FINAL
Environmental Impact Report

**1145 Market Street
Office Building**

October 20, 1983

9/27 4 10/17

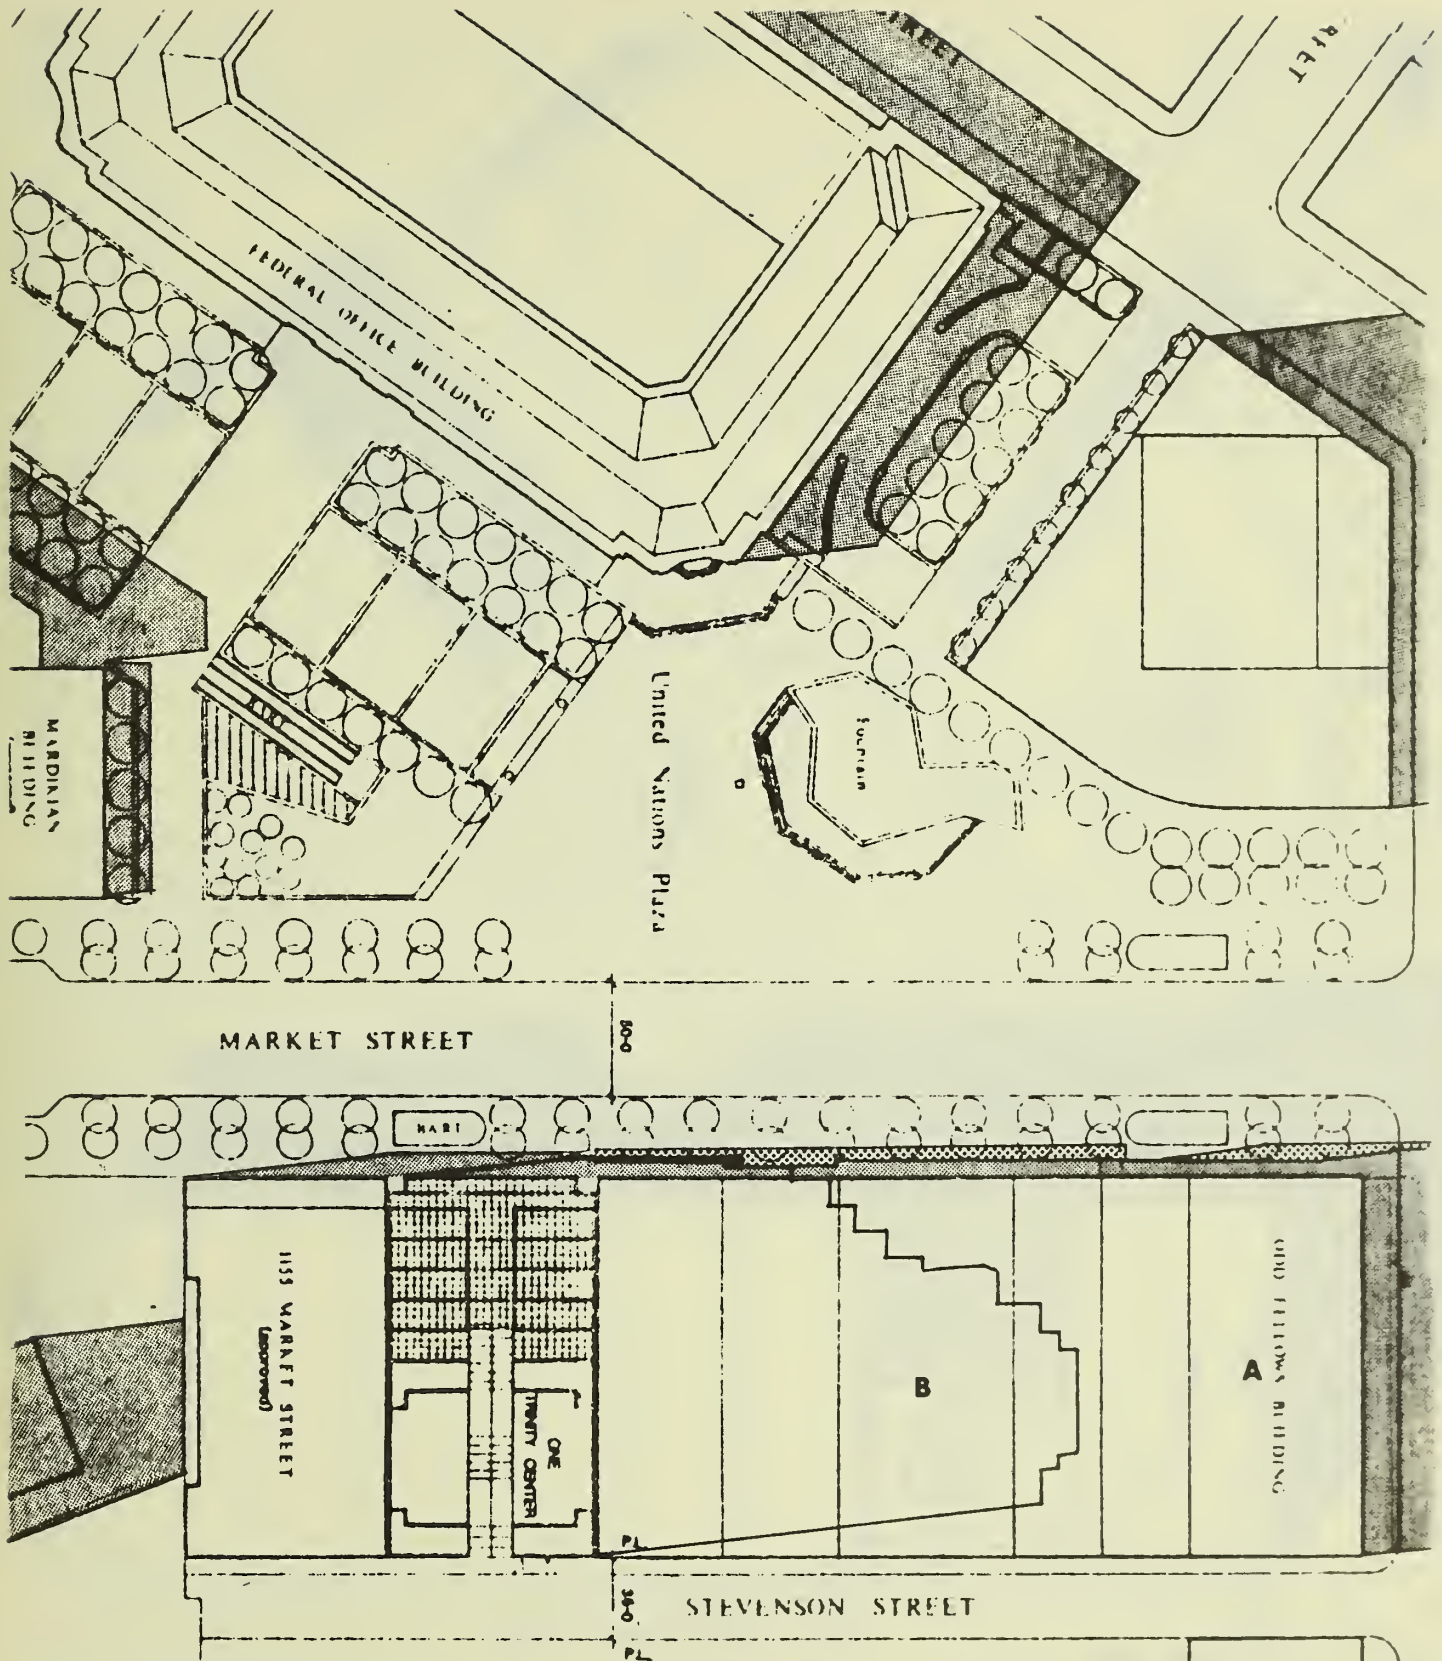
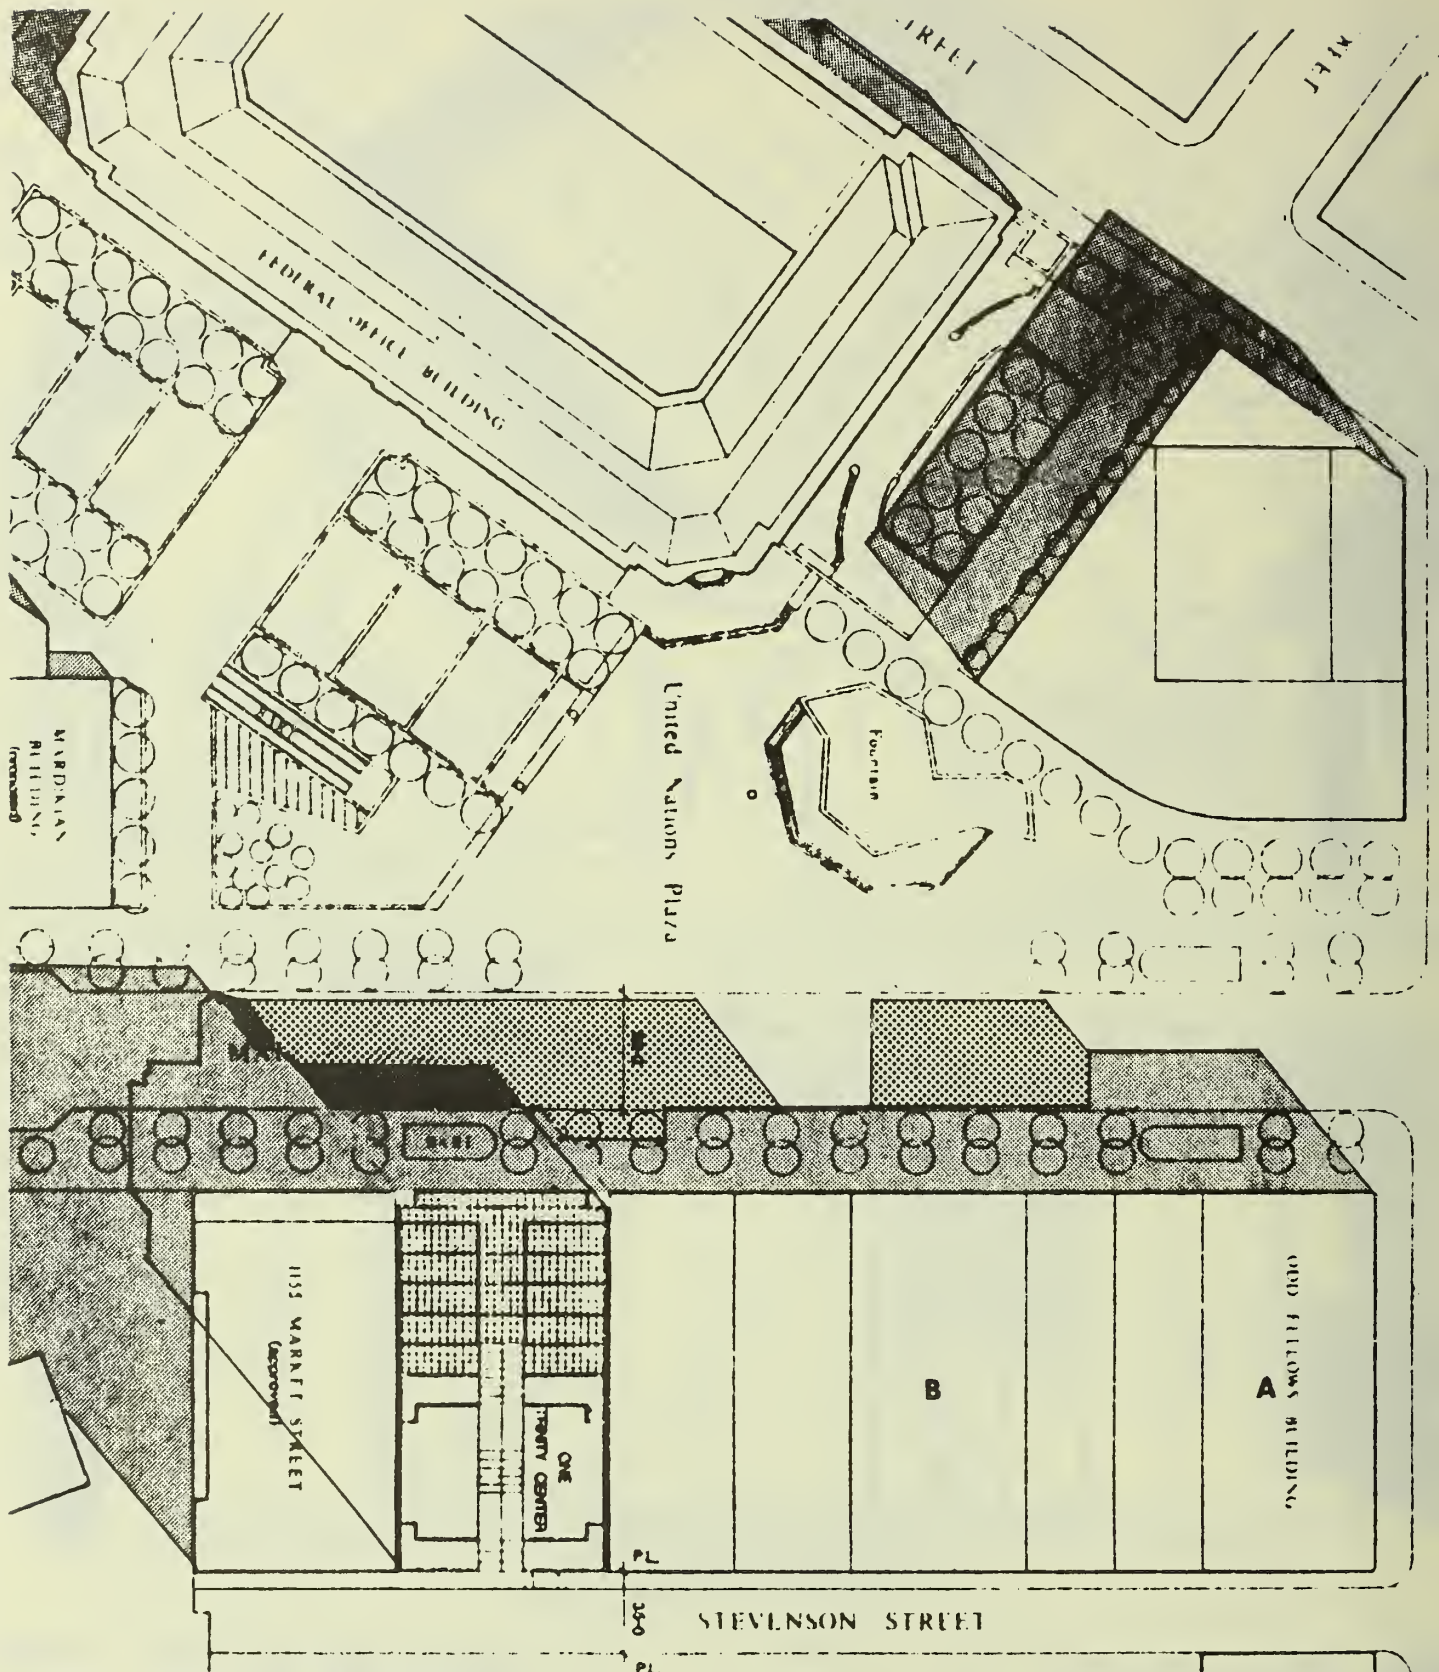
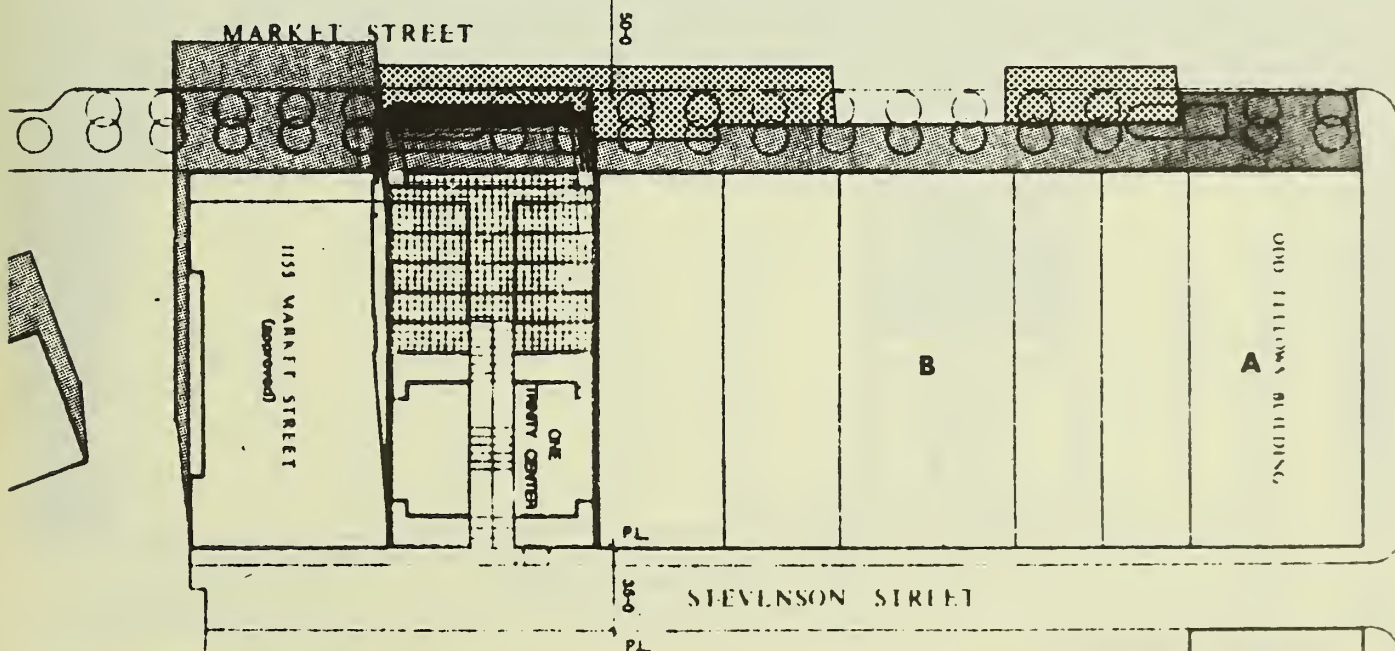
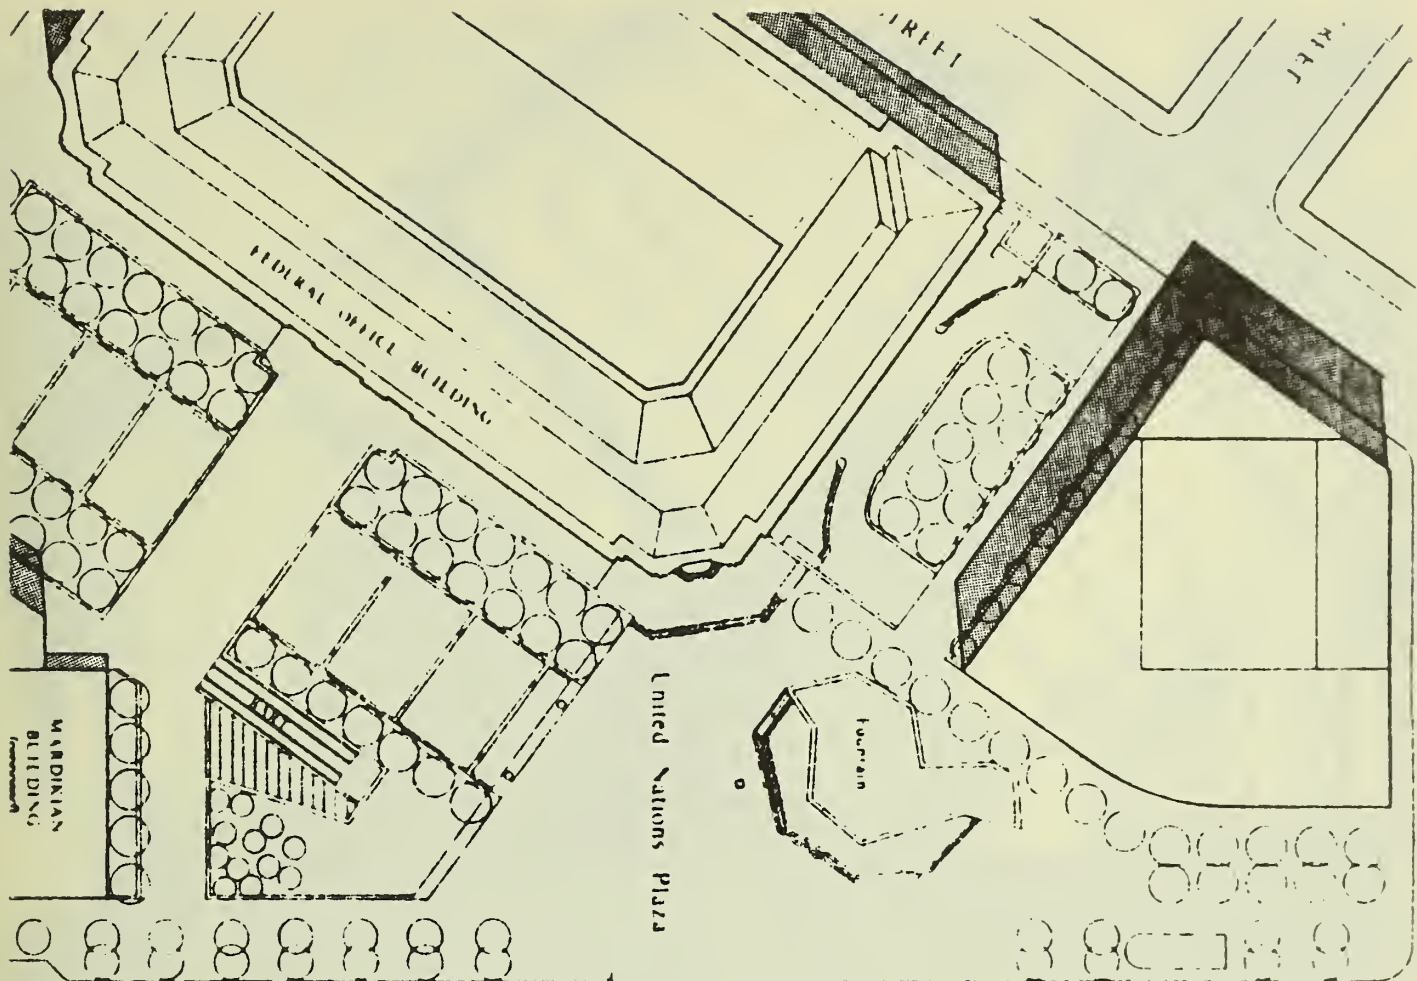
RESPONSE

The shadow analysis for the project was prepared as part of the Initial Study and Preliminary Negative Declaration issued by the Department of City Planning on May 21, 1982. The Initial Study is included as Appendix A of the EIR. On September 2, 1982, the Commission determined that an EIR was required on the proposed project providing further impact analysis for growth inducement cumulative transportation and cumulative air quality impacts; shadows were not identified as a potentially significant impact.

The shadow analysis indicates that the project would cast a shadow (assuming sunshine every day of the year) beyond the north curb of Market Street after 10:00 a.m. for about 200 days a year for about one and one-half to two hours on each morning during the months of January through March, September through December. The project would, in conjunction with other projects in the area, shadow a portion of the United Nations Plaza Fountain about 60 days a year for about one and one-half to two hours each day during the months of November through January. Although not precisely indicative of cloudiness conditions in San Francisco, it is noted that cloudiness measurements taken at the San Francisco International Airport show that

Shadow studies for the project have been prepared by Peter Bosselmann of the UC Berkeley Environmental Simulation Laboratory (ESL), which appear as Figures R-2 through R-10 on pages 25-33 of this document. The study reflects sun shading concepts and criteria introduced in the ESL report, Sun and Light for Downtown San Francisco, April 1983, which have been incorporated into the Department of City Planning's proposal for the Downtown Plan, August 1983. As compared to the shadow studies originally prepared for the project that appear on pages A-49 through A-56 of the EIR, the Bosselmann study uses the most current methodology.
